DART SERVICE INSTRUCTION

TO AMEND INSTALLATION INSTRUCTIONS IIN-D058-672 REV. C AND INSTRUCTIONS FOR CONTINUED AIRWORTHINESS ICA-D058-672 REV. 1 REF. FAA STC: SR00912SE

FOR D058-672-011/-012/-013/-014 SKID TUBES @ CHANGE 004 AND SUBSEQUENT, THE D2707-043 OR D2968-043 TOW RING HAS BEEN REPLACED WITH D3407-043 TOW RING ASSEMBLY.

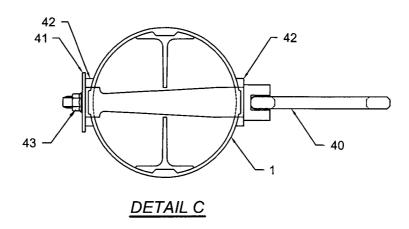
AMEND THE PARTS LIST IN SECTION 5.0 OF INSTALLATION INSTRUCTIONS IIN-D058-672 REV. C AND SECTION 32.9 OF THE INSTRUCTIONS FOR CONTINUED AIRWORTHINESS ICA-D058-672 REV. 1 AS FOLLOWS:

,				,			
40	1	1	1	1		D3407-043	TOW RING ASSEMBLY	
41	1	1	1	1		D3456-1	WASHER	
42	2	2	2	2		D3457-1	WASHER	
43	1	1	1	1		MS21043-4	NUT	
L	l

l	1		
40	1	1	1	1	D2707-043 (OR D2968-043)	TOW RING	•
41	1	1	1	1	AN960JD1016	WASHER	
42	1	1	1	1	AN970-4	WASHER	
43	1	1	1	1	MS21042-4	NUT (OR MS21042L4)	
					1,

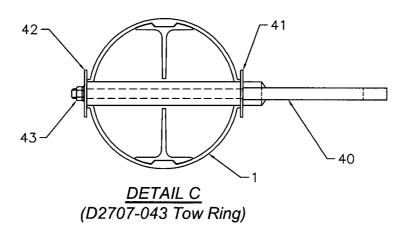
INSTALL TOW RING ASSEMBLY AS SHOWN BELOW (REFER TO DETAIL C OF IIN-D058-672 REV. C AND DETAIL C OF ICA-D058-672 REV. 1). AMEND SECTION 3.5 OF OF IIN-D058-672 REV. C AND SECTION 32.5 OF ICA-D058-672 REV. 1 ACCORDINGLY.
